Title: **QUALITY AUDIT  
INCLUDING ROAD SAFETY AUDIT STAGE 1  
CASTLEFORBES DEVELOPMENT**

Report reference: **0899R01**

This report was prepared in response to a request from Mr. Nick Fennor, DBFL Consulting Engineers for a Quality Audit of the proposed Castleforbes Development on behalf of Glenveagh Homes.

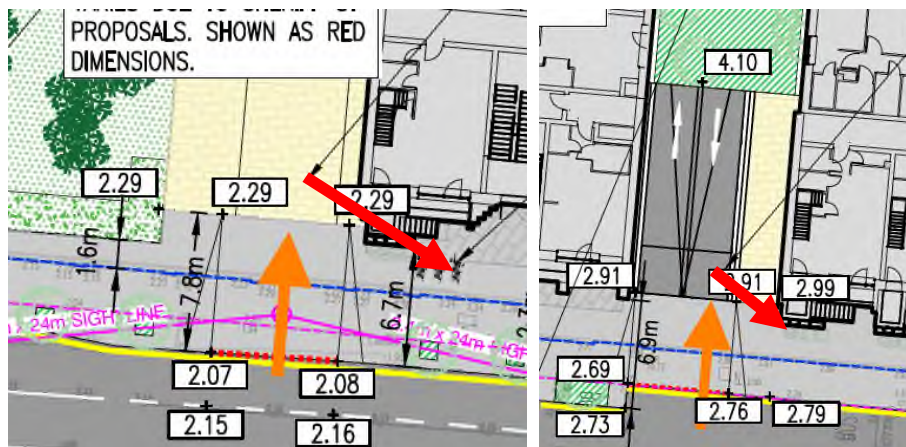
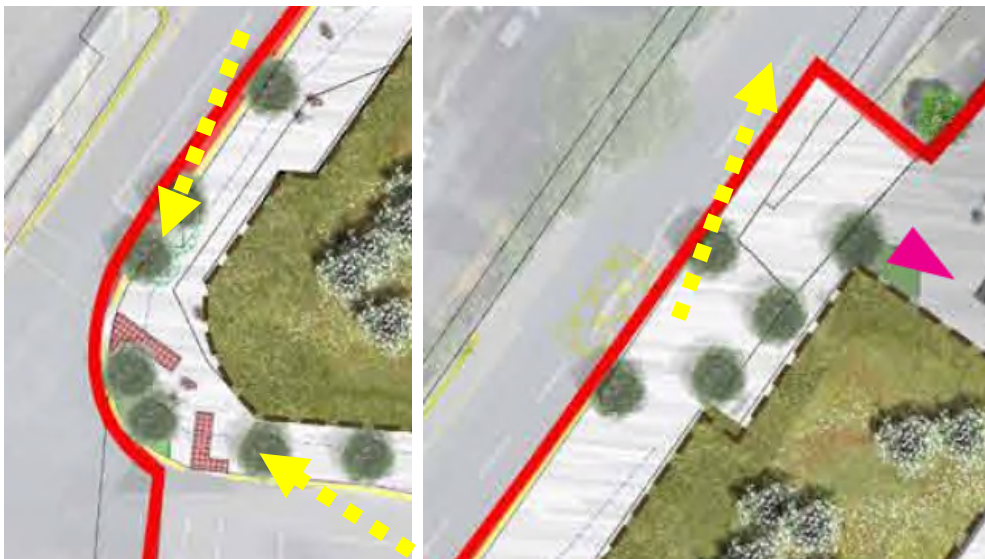
It is unclear if there will be sufficient visibility for drivers exiting the basement car parks to pedestrians or cyclists on the footpaths on Sheriff Street Upper. Without adequate visibility collisions could occur.

It is recommended that the visibility envelopes for pedestrians at the interface between the accesses and the footpath be kept clear of obstacles and building elements.

stop. Should DCC allow the applicant to relocate the bus stop, and grant the necessary licenses, then same will be facilitated.	
3.3	Yes	Yes		
3.4	Yes	Yes

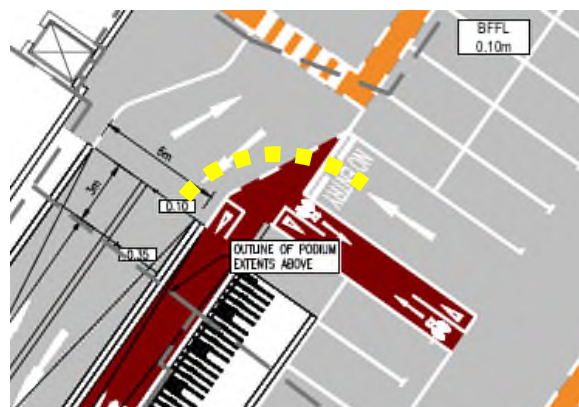
It is unclear if vehicles exiting the western basement can undertake the left hand turn at the base of the ramp without colliding with the structural wall or the dividing strip between the downward and upward lane in the ramp.

It is recommended that a swept path analysis be carried out for this manoeuvre to be sure that it can be easily undertaken by all classes of vehicles that are expected to use the basement car park.

3.6	Yes	Yes		
3.7	Yes	Yes	Electric vehicle (EV) parking provisions have been allowed for as part of the development proposals. The exact location of the EV parking spaces will be identified during the detailed design stages of the project in coordination with other services and utilities in the basement.	Yes

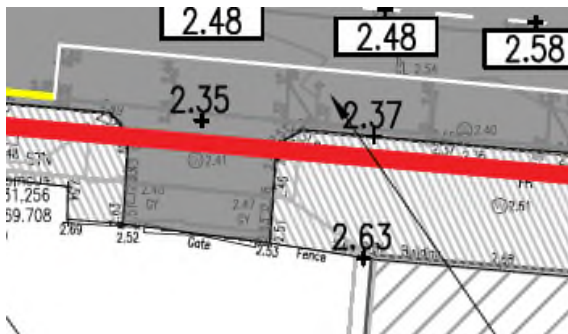
As there is no surface disabled car parking it is important that the basement levels allow for the height required for high top conversion vehicles.

It is recommended that the minimum space of 2.6m (Part M of Building Regulations) be allowed for High top conversion vehicles or that supplementary surface parking for such vehicles be provided.

3.9	Yes	Yes

PROJECT		CASTLEFORBES DEVELOPMENT	
DRAWING TITLE		ROADS LAYOUT	
CLIENT		GLENVEAGH	
Designed by	Author	Scale	Sheet Size
NLF	BS	1:500	A1
Drawing no.	180159-2100 P02

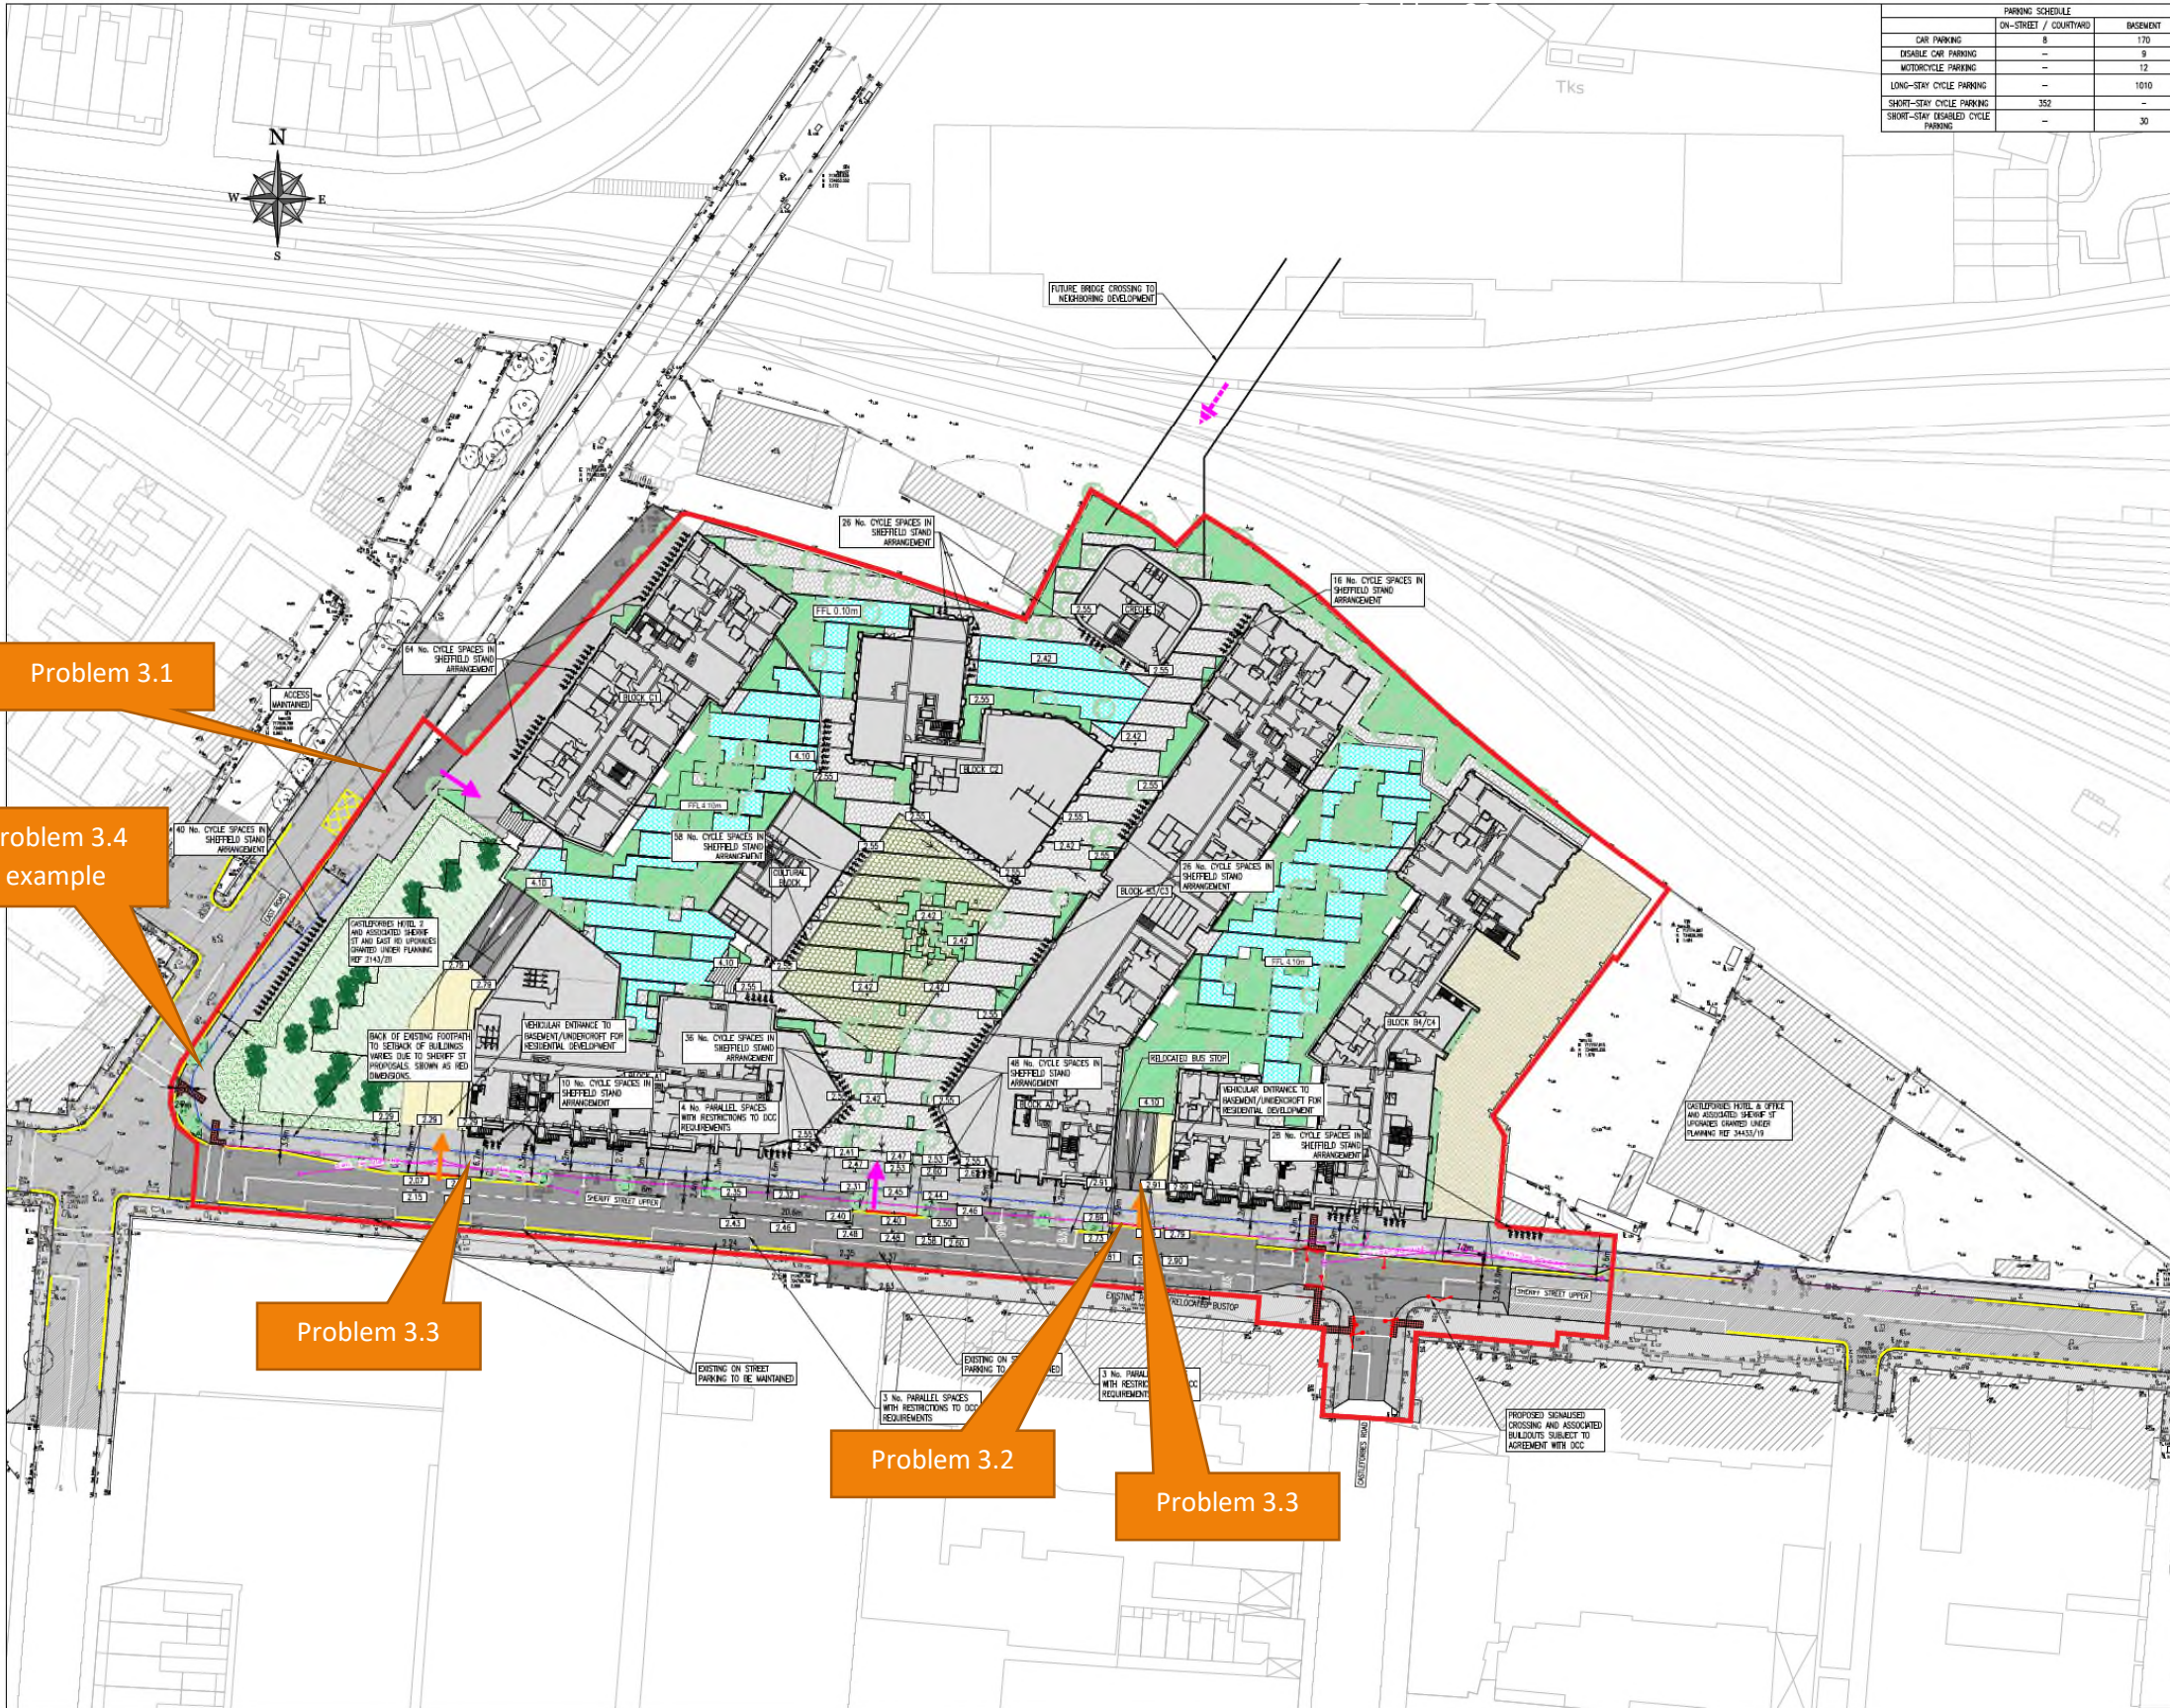
The proposed pedestrian access on East Road does not have a clear route for pedestrians from the public footpath. There is a possible pinch point at the hotel site and pedestrians have to share space with vehicles coming up and down the ramp to the commercial units to the North of the development.

It is recommended that a wide and clearly defined route be provided for pedestrians without having to share space with commercial vehicles. Gradients for pedestrians should be no steeper than 5%.

The bus stops On Sheriff Street Upper are in close proximity to the vehicular entrance to the basement car park. There is a risk that parked buses will obscure visibility for drivers exiting the car park leading to cars being stopped on the footpath blocking the path of pedestrians.

The Buildout for the eastbound bus lane is within the swept path for drivers turning left into the car park and could lead to reversing movements to complete the manoeuvre.

It is recommended that the bus stops be located where they do not obstruct movements or visibility from the development accesses.

3.1	Yes	No	<p>The existing vehicle access off East Road, to the west of the proposed development, is for access to an existing Irish Water Pumping Station. While we acknowledge that pedestrians will occasionally encounter vehicular traffic from this area, it is anticipated that this will be low given that the only vehicles entering this space will be staff for the Irish Water Pumping Station and that no pedestrian access to the proposed development is being proposed to the north of the access highlighted.</p> <p>As alternative measure, the landscaping proposals will be amended at detailed design to reduce the green landscaped area to facilitate a wider pedestrian entrance to minimise pedestrian/vehicular conflicts</p>	Yes

3.2	Yes	No	<p>We acknowledge that this concern may arise given the proximity of the bus stop to the basement entrance/exit. The location of the bus stop could be relocated away from the basement entrance/exit; however, the area is outside the control/ownership of the applicant and in the charge of DCC. We agree to approach DCC to relocate this bus</p>	Yes
